NEW AUSTRALIAN / NEW ZEALAND STANDARD PLUG

We would like to inform you that the new Australian / New Zealand Standard 3112-2000 has been published. A major change in the standard is the introduction of insulated plug pin. This new style of plug will be mandatory within 5 years after the publication of this standard, please find the picture below for the new style of plug.

INSULATED PINS

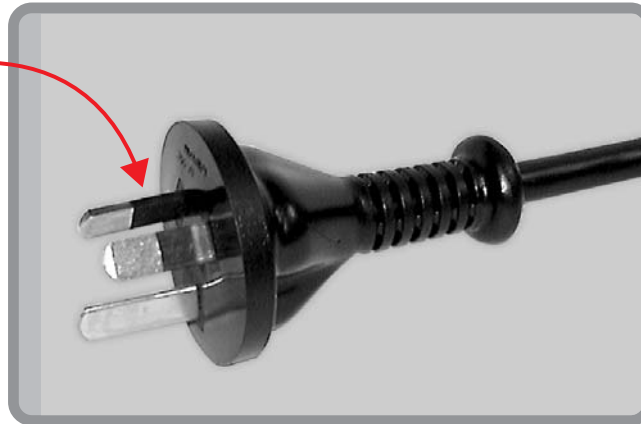
Using the insulated pins allows the deletion of the round boss requirements and allows non-circular plug shapes, the insulated pin plug shall be with all live pins in accordance with the Standard.

Both active and neutral pins are considered to be live.
